Technical modifications carried out on our baby models

1012-30 R02

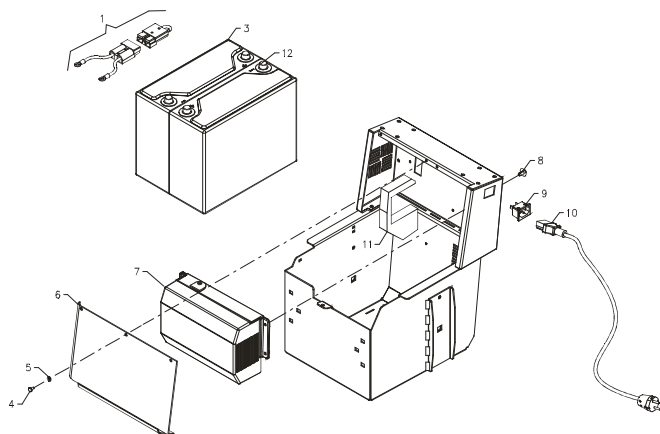
→ Starting from serial number: 12002339 dated 05/07/12 **baby plus**

We have replaced the fuse with the connector (pos. 1).

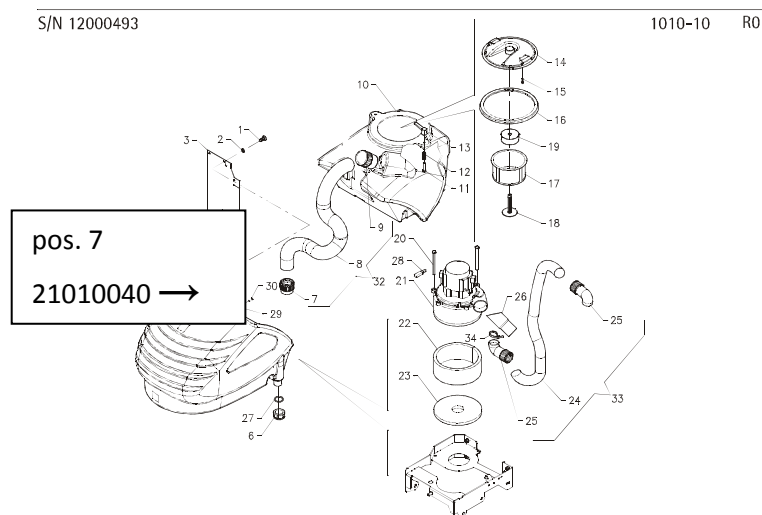
→ Starting from serial number: 12001452 dated 20/04/2012 **baby at 24V and 230V**

The material of the squeegee hose coupler (pos. 7) has become softer, so that it can be inserted more easily onto the squeegee. The coupler is interchangeable and the part number 21010040 remains unchanged.
